TECHNICAL INFORMATION

Document: TI_T318_033
Date: 01/09/2020
Subject: Front flap adjustment plate

Reference:	Table	Item	Code
	03-A	16	2403055
	03-A	17	2403056

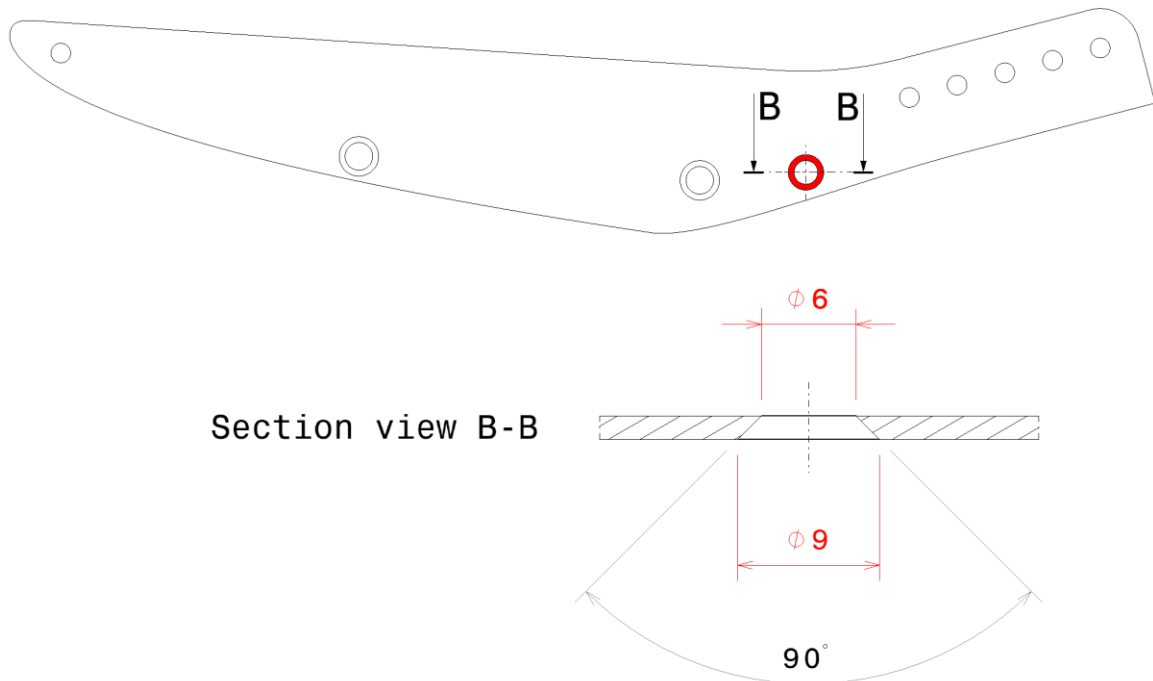
It is allowed to adjust the countersink of the hole for the UNI5933-M4 screw on p/n 2403055 and 2403056 in order to have a smoother installation of bolts' head.

Please note that also the countersink on the flap could need to be adjusted accordingly.

Please refer to the drawing below as a reference for the countersink dimensions:
